**Office of Legacy Management Response to U.S. Nuclear Regulatory Commission's
October 30, 2019, Comments and Request for Additional Information**

*RE: Comments and Request for Additional Information, Draft Groundwater Compliance Action
Plan, Gunnison, Colorado, Processing Site
Docket No. WM-00061*

SUBJECT: GUNNISON, COLORADO, PROCESSING SITE – REQUEST FOR
ADDITIONAL INFORMATION RE: DRAFT GROUNDWATER COMPLIANCE
ACTION PLAN

Figure 5. Example of revised Sector 2 (purple boundary) for proposed ACL (adapted from the 2018 Annual Verification Monitoring Report for the Gunnison Processing site Figure 2 (DOE, 2019))

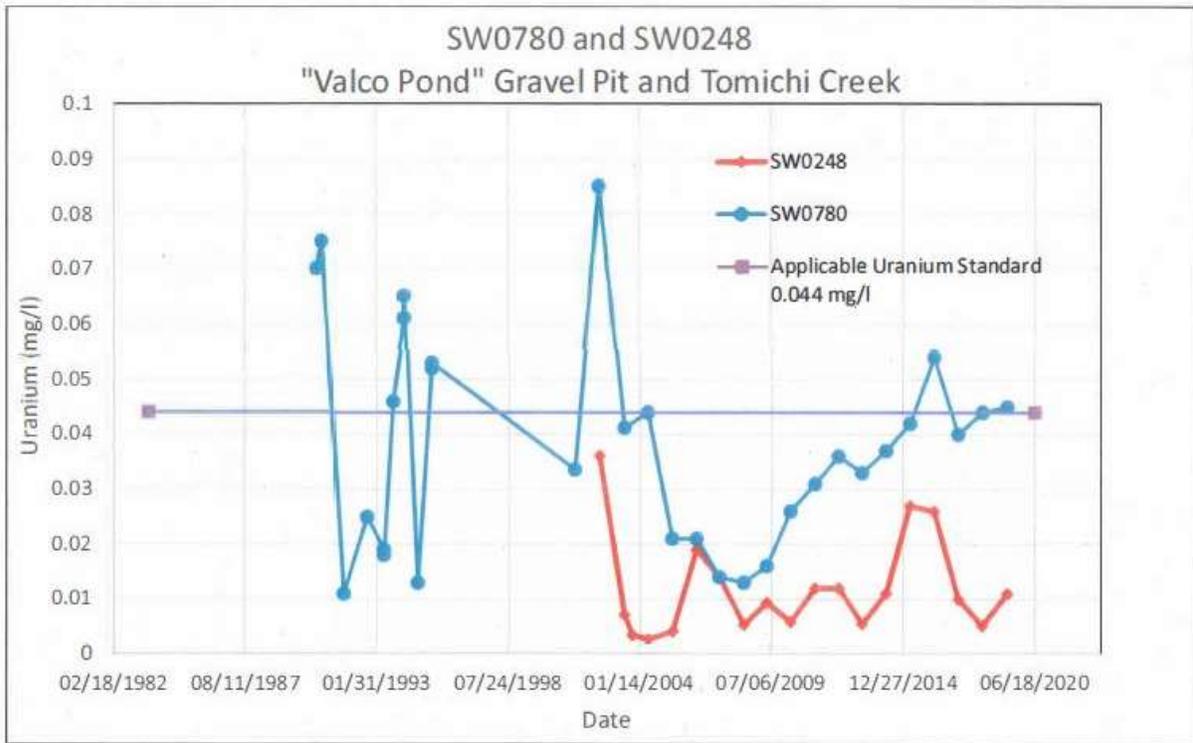
Comment 3: NRC staff requests that DOE propose a revised Sector 2 from the southern boundary of Sector 1 down to Tomichi Creek to include MW0113, the entire gravel pit operation and newly approved Gunnison West gravel pit expansion. An example of such a revised Sector 2 is shown in Figure 5 below. NRC staff finds there is compelling evidence that the alluvial groundwater in this revised Sector 2 will not achieve the uranium applicable standard of 0.044 mg/l in 100 years by natural flushing and therefore a proposed ACL of 0.56 mg/l derived from MW0113 historical uranium values is appropriate.

Basis: NRC staff finds that the proposed ACL of 0.56 mg/l uranium would be reasonable over a revised Sector 2 area extending south from the boundary of Sector 1 to Tomichi Creek and encompassing MW0113 and the new gravel pit operation to the west. An example of a revised Sector 2 area is shown in Figure 5 below.

Path Forward: NRC staff requests that DOE should reduce the Sector 2 area for the proposed ACL of 0.56 mg/l uranium to a revised Sector 2 area similar to the one shown in Figure 5 based on DOE's own assessment.

Basis: The NRC staff requests these POE well and POE surface water monitoring locations shown on Figure 5 for the following reasons:

Comment 6: NRC staff finds that there are no POE wells outside of the institutional control (IC) boundary directly south of the gravel pit operation in revised Sector 2 (Figure 5). A POE well is needed south of this IC boundary to monitor and ensure that unrestricted groundwater use will not pose a substantial present or potential hazard to human health and the environment.

Response	LM Comment Response	LM Comment Basis Response	LM Approach to Comment
	LM acknowledges NRC's Comment 3 and the NRC proposed revised Sector 2 boundary and will reevaluate the Sector 2 boundary.	LM acknowledges the basis NRC uses to select the revised Sector 2 boundary and does not disagree with any of NRC's statements. However, evidence and results from additional evaluations should be considered in selecting a revised Sector 2 boundary.	<p>As discussed in response to the Comment 2 Path Forward, LM will conduct a comprehensive analysis and will consider additional data, results from the evaluations of past, present, and future mine operations, and associated risks before proposing the sector boundaries.</p> <p>Risks associated with plume expansion due to gravel pit dewatering operations and other groundwater use will be evaluated to support the basis for determination of the sector boundaries. It is anticipated that a range of scenarios representing actual and potential groundwater use conditions will be evaluated to assess the potential for exposure and corresponding risks.</p>

Figure 1. Uranium plume from Sector 1 and new gravel pit expansion (adapted from the 2018 Annual Verification Monitoring Report for the Gunnison Processing site Figure 2 (DOE, 2019))

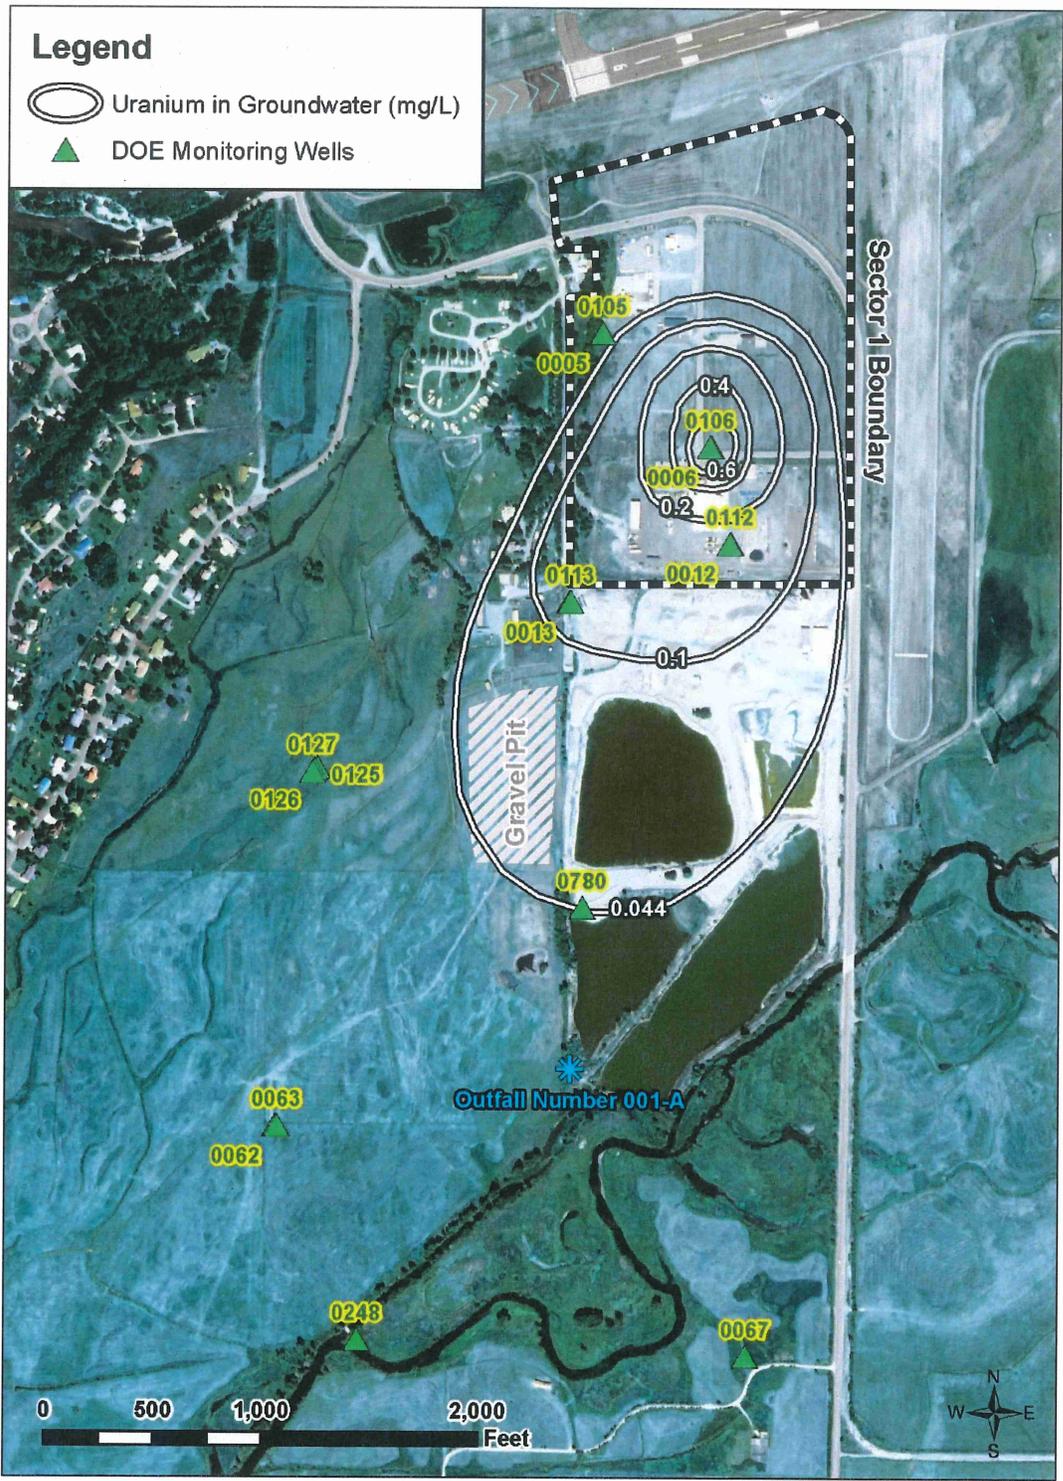
Comment 1: DOE has proposed a uranium Alternate Concentration Level (ACL) of 1.43 mg/l for all groundwater in the alluvial aquifer underlying the original Gunnison processing site boundary, renamed as Sector 1, in lieu of the original natural flushing remedy to the applicable uranium standard of 0.044 mg/l in Table 1 to Subpart A of Title 40 of the *Code of Federal Regulations* (CFR) Part 192 (DOE, 2017). NRC staff finds that the DOE has provided sufficient evidence that the current GCAP of natural flushing is unlikely to meet the applicable uranium standard of 0.044 mg/l uranium in proposed Sector 1. This finding is also supported by the current location of the uranium plume which exceeds the applicable uranium standard of 0.044 mg/l as shown below in Figure 1.

The new Gunnison West Gravel Pit Expansion operation was approved with new dewatering wells. In past gravel pit operations, dewatering wells have operated at rates up to 4000 gpm. These wells represent a new groundwater use south of the Sector 1 proposed ACL site. NRC staff finds the use of any new dewatering wells must be evaluated under present and potential hazard factors in 40 CFR 192.02 c(3)(ii)(B)(1)(iv) and (v). This evaluation is necessary to determine if and how the new gravel pit dewatering wells may impact the uranium plume and the uranium levels at the POE well MW0113 shown in Figure 1. In addition, the new dewatering wells are permitted to discharge to the "Valco Pond" gravel pit and may therefore impact the uranium levels in this gravel pond which are measured at SW0780.

Path Forward: NRC staff requests that DOE analyze the potential impact of any new gravel pit dewatering wells for the approved Gunnison West Pit Expansion. Specifically, DOE should determine if and to what extent the use of these gravel pit dewatering wells may impact the existing uranium plume shown in Figure 1 and the future uranium levels at MW0113. DOE has proposed MW0113 to be the Sector 1 POE well that will be required to meet the proposed Sector 2 ACL of 0.56 mg/l. NRC staff also requests that DOE evaluate any impact on the uranium levels measured at SW0780 in the "Valco Pond" gravel pit which will receive the dewatering well discharge from the new expansion gravel pit operation. The evaluation of this groundwater use and potential surface water impact is needed to meet the requirements of the factors in 40 CFR 192.02 c(3)(ii)(B)(1)(iv) and (v) for the proposed Sector 1 ACL.

Response	LM Comment Response	LM Comment Basis Response	LM Approach to Comment
1	LM will conduct further evaluation of the impacts on surface water and groundwater from the newly permitted Gunnison West Pit Expansion.	LM concurs with the stated basis and acknowledges that an evaluation into the change in groundwater use and associated impacts on surface water and groundwater needs to be made.	<p>LM acknowledges NRC's proposed path forward for Comment 1 and agrees that the impacts on surface water and groundwater from the new permitted Gunnison West Pit Expansion need to be evaluated. However, before selecting a specific approach to analyze the impacts, the mine permit documents will be reviewed to understand the proposed operations (dewatering schedule) and final build out. The mine plans will also be reviewed to assess the plans for potential future build outs in areas that could influence the impacted groundwater at the Gunnison, Colorado, Processing Site. Historical mine operations will also be reviewed in context of how development might have influenced groundwater flow in the vicinity of the site. Additionally, meteorological, surface water, groundwater elevation, and water chemistry data will be evaluated to better understand potential impacts from gravel pit operations. Meteorological data will be used to evaluate potential groundwater recharge (infiltration) and discharge (evaporation) volumes, groundwater elevation data that will be used to evaluate flow direction variability and if historical influences can be noted. Historical and current water chemistry data will be used to assess if changes in water chemistry correspond to build out of the gravel pits. The review and analyses of historical and current data in context of the mine operations will be used to identify additional data gaps and to establish approaches to fill the data gaps and potential identify risks associated with the expansion. Findings from the evaluation of potential impacts on Valco Pond water quality will be considered risk factors, which will be incorporated into the selected groundwater compliance strategy.</p> <p>The impacts on Valco Pond from dewatering activities will be also be assessed. Similar to the case above, the approach to evaluate impacts from dewatering activities on Valco Pond will be selected following an initial comprehensive review of pertinent surface water data, groundwater data, and the associated mine plans.</p>

Figure 2. Uranium plume from Sector 1 and uranium in downgradient (adapted from the 2018 Annual Verification Monitoring Report for the Gunnison Processing site Figure 2 (DOE, 2019))

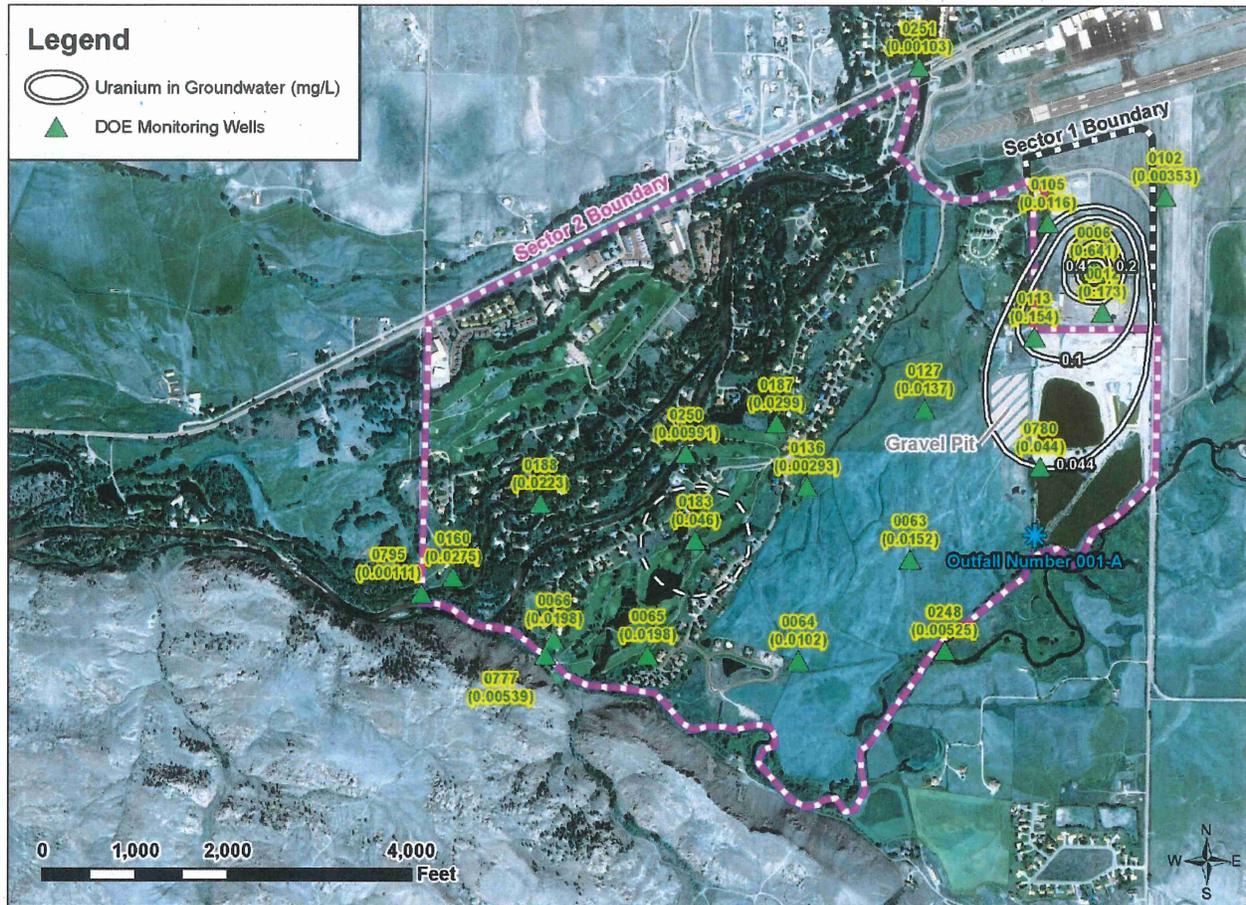
Comment 2: NRC staff does not agree that the current GCAP of natural flushing is failing or will fail to meet the applicable uranium standard of 0.044 mg/l in the entire area of proposed Sector 2 shown in Figure 2 below. In contrast, NRC staff finds the current GCAP of natural flushing is meeting and will continue to meet the applicable uranium standards of 0.044 mg/l for almost the entire Sector 2 area, excluding the area just south of Sector 1. Therefore, NRC staff does not understand the basis for DOE to propose an ACL of 0.56 mg/l for uranium in the entirety of Sector 2 which covers 928 acres (1.45 square miles) with an aquifer thickness ranging from 70 - 130 feet thick. Assuming an average thickness of 100 feet, NRC concurrence on this proposed ACL would permanently affect over 92,800 acre feet of water and is not justified. The NRC staff are concerned with the future use restrictions to such a large area of groundwater.

NRC staff, however, finds that DOE has not provided compelling evidence that the natural flushing remedy is failing for the downgradient plume in the entire alluvial aquifer in Sector 2 and that the goal of achieving the applicable uranium standard of 0.044 mg/l should be abandoned in lieu of an ACL. In contrast, NRC staff finds the natural flushing remedy has been and continues to be successful in the majority of the alluvial aquifer in Sector 2, with no compelling evidence that all of the alluvial aquifer in Sector 2 will exceed the applicable uranium standard of 0.044 mg/l.

In Sector 2, the groundwater moves to the southwest from the original Gunnison Processing site at a yearly rate of approximately 690 to 1150 ft/year according to hydraulic conductivity and gradient values provided in the revised GCAP (DOE, 2017). As shown below in Figure 2, the uranium concentrations in the downgradient monitoring wells across Sector 2 are all below the applicable uranium standard of 0.044 mg/l with the exception of a slightly elevated uranium level at MW0183 of 0.046 mg/l.

Response	LM Comment Response	LM Comment Basis Response	LM Approach to Comment
	<p>LM acknowledges that NRC staff does not agree that natural flushing is failing for the entire proposed Sector 2. The basis for proposing the boundary for Sector 2 was to fully encompass the extent of contamination as outlined in the 2010 GCAP and that it would not restrict future domestic use because the groundwater use within the boundary is already restricted due to the IC described as the New Domestic Well Constraint Area for the Dos Rios area of the county. At the suggestion of NRC, LM will reevaluate the Sector 2 area to better discern the extent where compliance standards need to be applied.</p>	<p>LM acknowledges that NRC's assessment provides evidence that natural flushing may be successful in the downgradient monitoring wells. LM also acknowledges NRC's concern that the Sector 2 boundary encompasses areas where there are indications that natural flushing as a remedy may be successful and areas where no former mill operations groundwater contamination currently exists or is likely to ever exist. LM agrees that a revised Sector 2 boundary that includes natural flushing and ACLs may be an appropriate compliance strategy.</p>	<p>LM concurs with NRC's request to withdraw the proposed ACL for all of Sector 2 and maintain the natural flushing remedy. LM also agrees with NRC that ACLs are an appropriate compliance strategy; however, appropriate sector boundaries, POEs, and POCs need to be selected to ensure protection of human health and the environment. Thus, LM agrees to evaluate a revised Sector 2 boundary to support the final compliance strategy.</p> <p>In the absence of an analysis of the potential impacts from the gravel pit expansions (see NRC Comment 1) and not having evaluated data with regard to selecting a compliance strategy since 2017, LM proposes to conduct further review and analysis, to supplement prior analysis by LM and NRC, as a component of developing a revised compliance strategy. LM first proposes to evaluate the success of natural flushing with respect to the different areas and then conduct the appropriate analyses as suggested in the response to the path forward to Comment 1. LM's data analyses will include a review of data and the use of additional tools that expands on NRC's assessment provided above. Specifically, LM proposes to evaluate well concentration data and account for the influences of site history, land/water use, and impact of mine plans and operations on the groundwater concentrations to fully evaluate natural flushing. LM plans to use three-dimensional volumetric modeling software to synthesize and spatially and temporally integrate the concentration data and water-level elevation data. Conceptual and statistical trends of well concentration data and bulk plume metrics will help determine natural flushing progress. The initial review of natural flushing performance will be performed during the initial data review before data gaps are identified and final evaluations are conducted.</p> <p>Evidence stemming from the initial data evaluations and volumetric and spatial modeling will be used to confirm if ACLs will be necessary for the site and at least partially inform potential Sector 1 and Sector 2 boundary limits. The approach to define the application of ACLs, boundaries, and associated POE and POC wells is discussed in the response to Comments 3, 4, 5, and 6 below. DOE agrees with NRC findings and will provide evidence or basis for the ACL boundaries in compliance with 40 CFR 192. As part of this, LM will also evaluate the need for additional ICs as necessary.</p>

Figure 3. Uranium levels in MW0113, MW0126 and MW0127 vs. applicable uranium standard (0.044 mg/l)

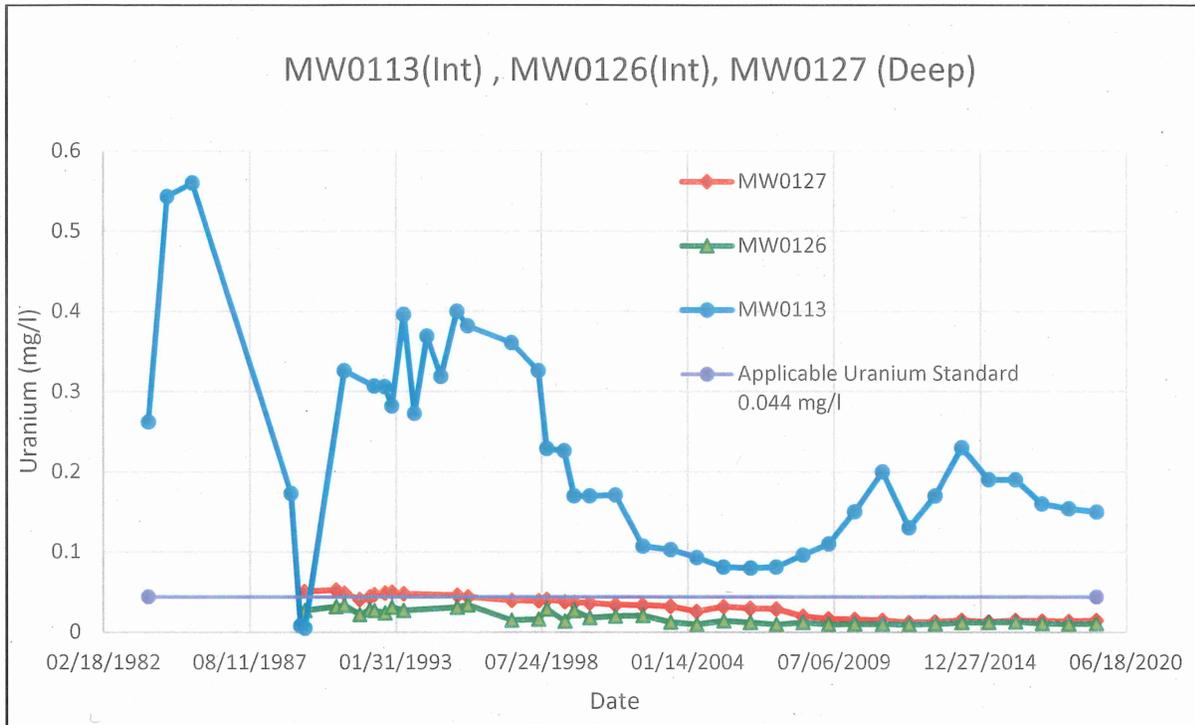
In its review, NRC staff found that DOE based the increasing trend in uranium and therefore failure of the natural flushing remedy in all of Sector 2 mostly on one well, MW0113, which lies immediately adjacent to the southwest corner of the original processing site as shown in Figure 1. DOE showed this upward trend as a deviation from the predicted natural flushing model in Figure 4 of the draft GCAP (DOE, 2017).

NRC staff's independent review of the monitoring well data for MW0113 is shown in Figure 3 below. The uranium levels in this well showed a significant decrease in uranium from 0.56 mg/l to 0.081 mg/l, from 1985 to 2007. The well then displayed a mild increasing trend up to 0.23 mg/l uranium from 2008 to 2014. However, from 2015 to 2019, the MW0113 data shows the upward trend in uranium has reversed and is now stable around 0.15 mg/l uranium as shown in Figure 3. In addition, the NRC staff's review of wells immediately downgradient of MW0113 showed this increase was not reflected in the downgradient wells, even though it was present for seven years. Specifically, MW0126 and MW0127, also shown on Figure 3, are the closest wells located 1039 feet directly downgradient of MW0113. These wells show significant decreasing trends with natural flushing in Figure 4 and have remained significantly below the 0.044 mg/l uranium standard since 1998. NRC staff review of these wells and of all other downgradient wells in Sector 2 indicate that the anomalous increase in MW0113 was naturally attenuated as predicted and did not impact downgradient wells.

NRC staff finds that the only well in Sector 2 that had a brief increasing trend of concern was MW0113 located in the far northeastern border of Sector 2 on the southwestern corner of the original Gunnison processing site identified as Sector 1. NRC staff found the increasing trend in uranium in the MW0113 has reversed and is now declining. In addition, NRC staff finds this well is immediately adjacent to the original processing site and is therefore not representative of all the downgradient wells in Sector 2 which remain substantially below the applicable uranium standard of 0.044 mg/l. NRC staff finds this well is not representative of the entire Sector 2 downgradient water quality and is not impacting downgradient wells. It should therefore not be used as the main basis to propose an ACL for Sector 2.

Figure 6. Uranium levels in SW0248 and SW0780 vs. applicable uranium standard (0.044 mg/l)

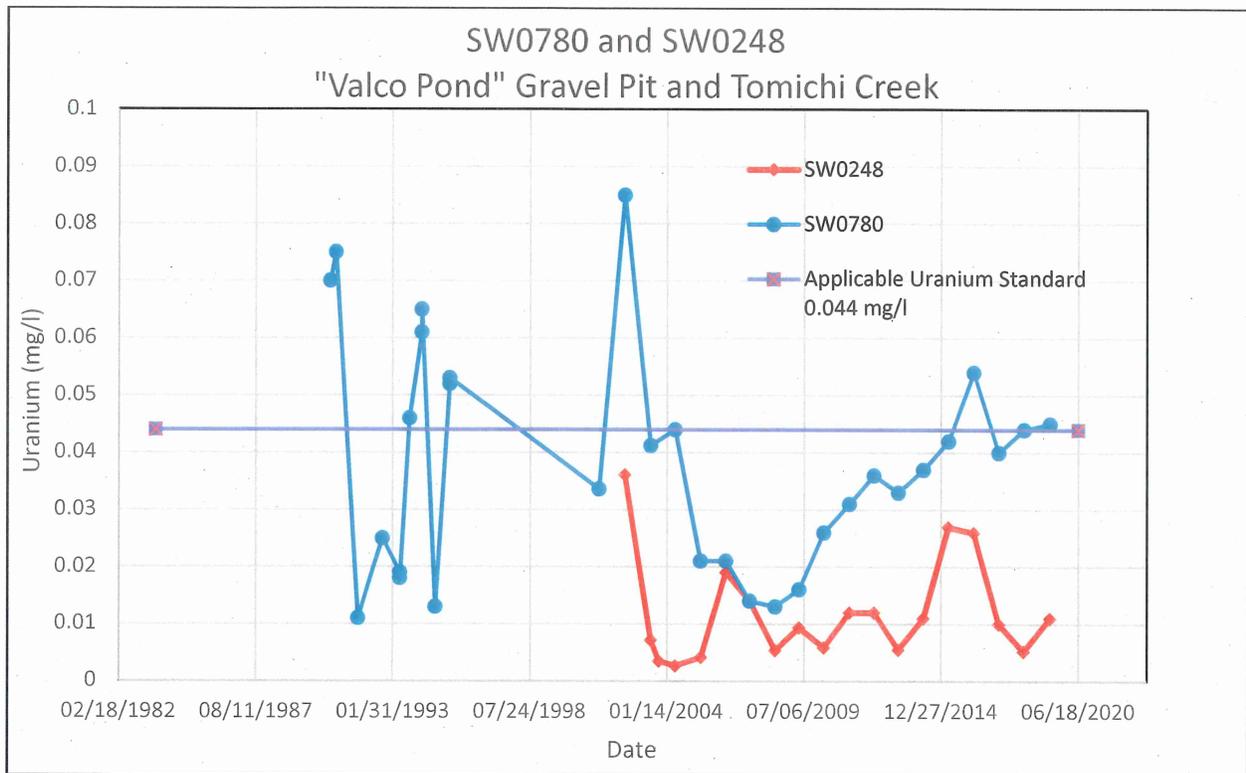
4. The uranium levels in SW0780 over time at the "Valco Pond" gravel pit within this revised Sector 2 have been below the applicable uranium standard of 0.044 mg/l but are now increasing above it as shown in Figure 6 below.

6. SW0248 is appropriate as a surface water POE because it has been consistently below the applicable uranium standard of 0.044 mg/l as shown in Figure 6 below.

Response	LM Comment Response	LM Comment Basis Response	LM Approach to Comment
	LM acknowledges NRC's Comment 5, NRC's acceptance of the proposed ACL of 0.56 mg/L for Sector 2, and the NRC proposed POEs MW0125, MW0126, MW0127, MW0062, MW0063, SW0780 on the Valco Pond gravel pit, and SW0248 on Tomichi Creek for Sector 2.	LM acknowledges the basis NRC uses to select the POE wells for Sector 2. However, LM would like to confirm this recommendation using results from additional evaluations (as discussed in response to Comments 1, 2, and 3 Path Forward).	LM acknowledges the POEs for NRC's proposed revised Sector 2 boundary and understands NRC's proposed path forward. However, LM would like to select the POEs following the completion of additional evaluations (as discussed in response to Comments 1, 2, and 3 Path Forward). It is expected that POEs will be selected based on analysis of plume time series and volumetrics, as well as groundwater flow direction calculations. The use of an analytical model, updated groundwater model, or other appropriate tool may also support the selection of POEs.
